MEMORANDUM

Subject: Staff Recommendations for June 15, 2017 Planning Board Meeting

Date: June 14, 2017

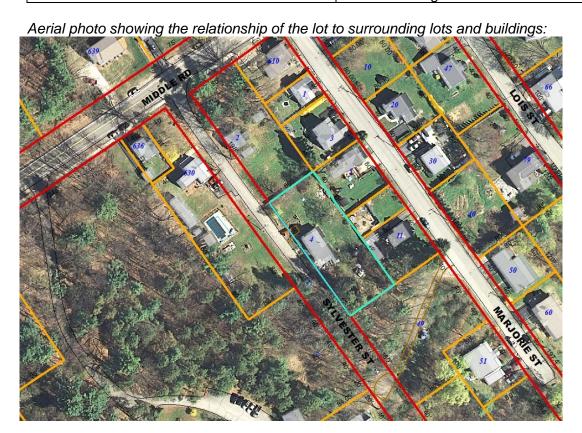
Required Findings	Planning Department Comments
Exterior design of the ADU is compatible with the existing residence on the lot through architectural use of building forms, scale and construction materials.	To increase compatibility of the design with the existing residence and surrounding properties, Planning staff has recommended that the applicant consider modifying the roof to a steeper pitch and changing the garage doors to double bays with windows.

Required Findings		Planning Department Comments
2.		The location of the proposed DADU will be on a portion of the property that is more heavily vegetated. Both the primary dwelling and the DADU will have access to usable open space. However, the need to expand the parking area will decrease the amount of usable open space available for the primary dwelling. No additional landscaping has been proposed.

4.	The ADU will not result in excessive noise, traffic or parking congestion.	The applicant is proposing to expand the parking area to accommodate parking needs, the DADU will be located on a part of the property that is setback from abutting residences. DPW is currently reviewing the proposed location and staff will provide an update at the Planning Board meeting.

Planning staff is reviewing this application with DPW and will report back with a recommendation at the Planning Board meeting.
